THE OAKS GROUP, PA

RE: Lot 1353 The Point Fast Tract Septic Redraw Request

Lot 1353 The Point Subdivision Fast Track

PHASE 13 LOT #1353

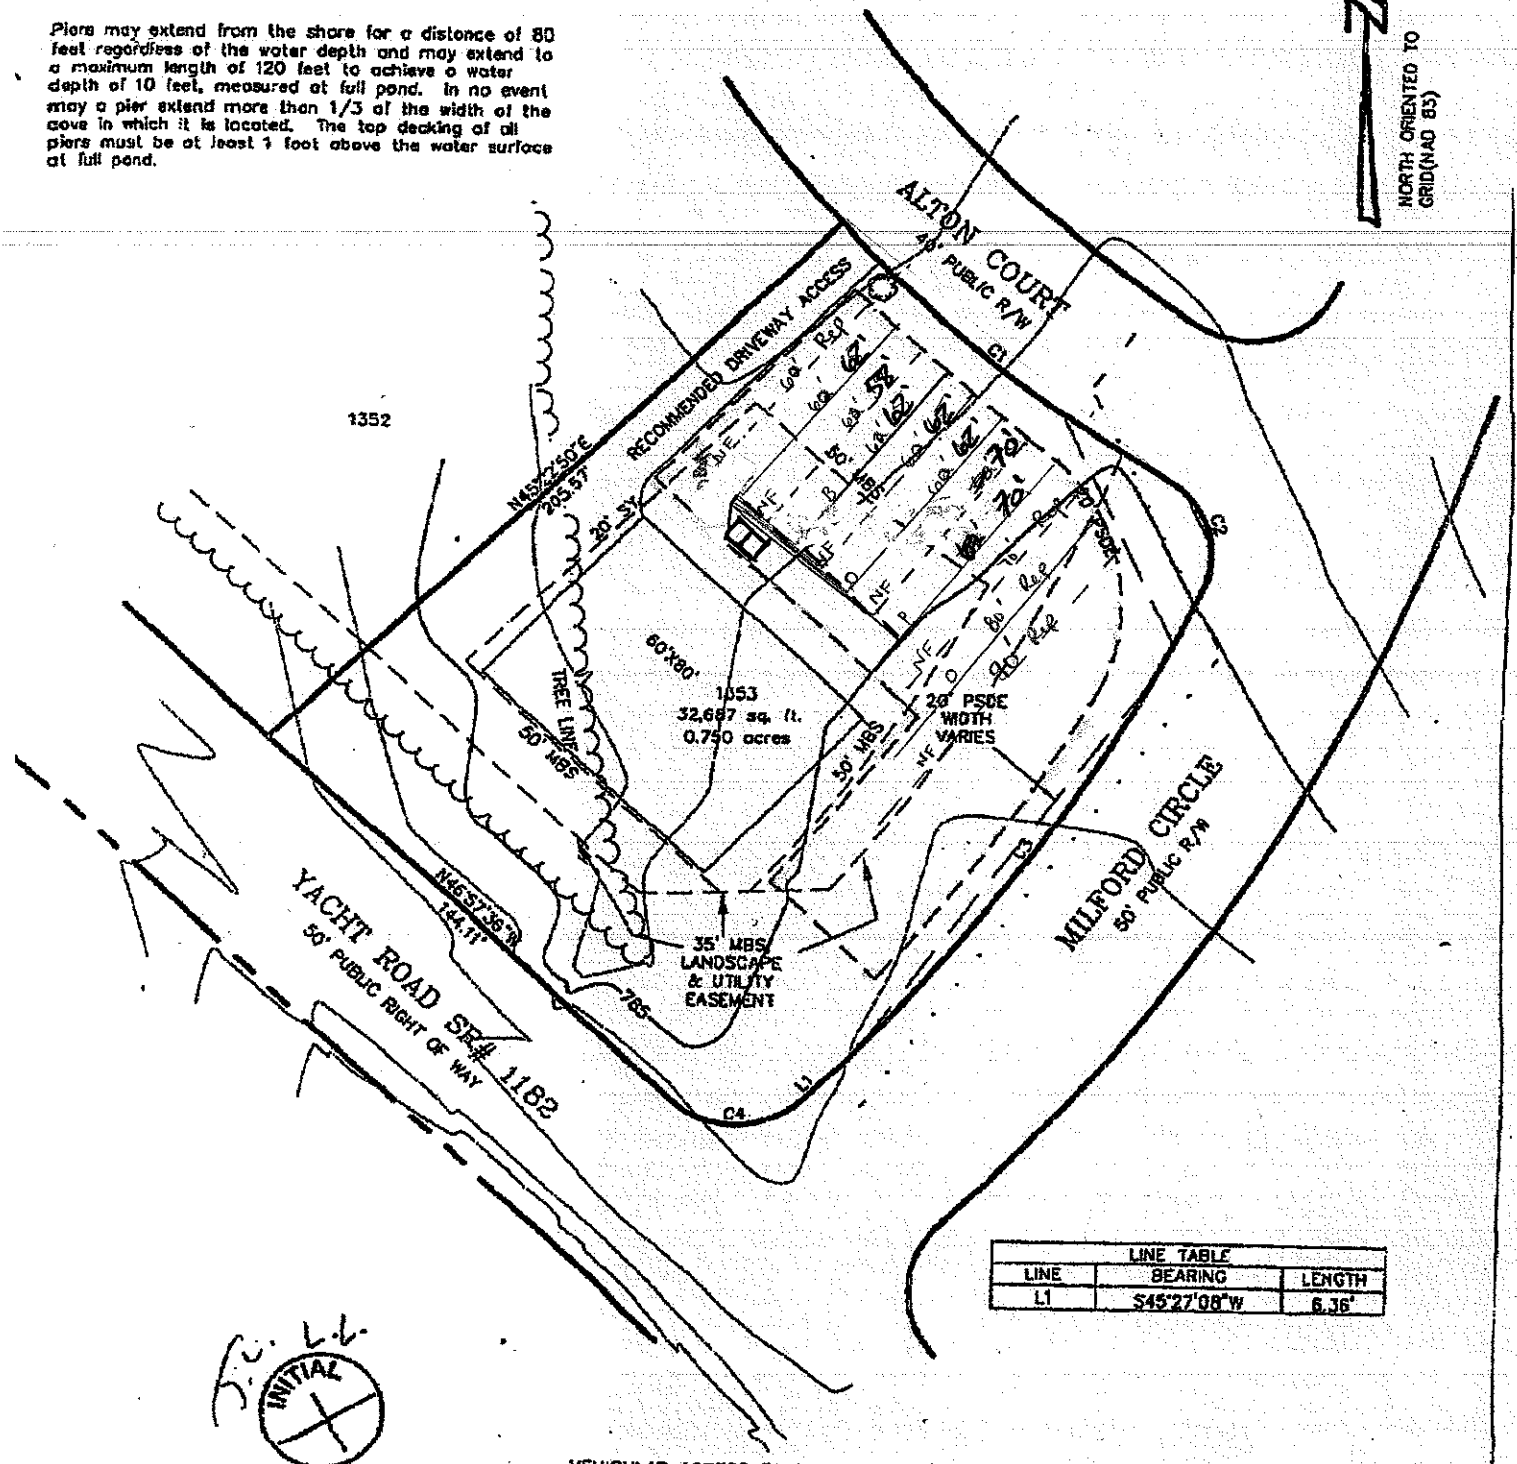
This packet is a redraw of a previously issued permit that is unexpired at this time. Two auger borings were completed to check the current permit's loading rate. The borings showed soils capable of a higher loading rate, however since the original permit's evaluation was done with backhoe pits, soil features may have been encountered during the original evaluation that were not encountered in this evaluation. Therefore, the original loading rate of 0.275 was used for this system design application. Please call me at 704-578-4951 with any questions and to set up a site visit at your convenience.

Note: Existing system not expired. Utilizing previous LTAR and system/repair lines Measured 0-2% slope across system area; lines laid 9 feet on center. May deviate from contour slightly.

Note: **Existing permit not expired. Utilizing previous LTAR and system/repair lines Measured 0-2% slope across system area; lines laid 9 feet on center. May deviate from contour slightly.**
